AMENDMENT NO. 1 MAY 1990
TO
IS : 4914 - 1983 SPECIFICATION FOR TAP
WRENCHES, ADJUSTABLE

(First Revision)

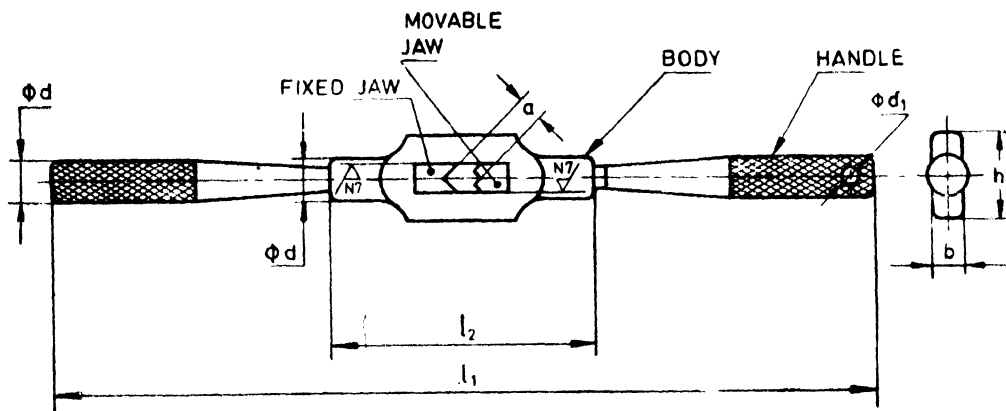
(Page 1, clause 2, Fig.) — Substitute the following for the existing figure:

NOTE : ϕd_1 shall be approximately one third of handle dia, rounded off to nearest whole number.
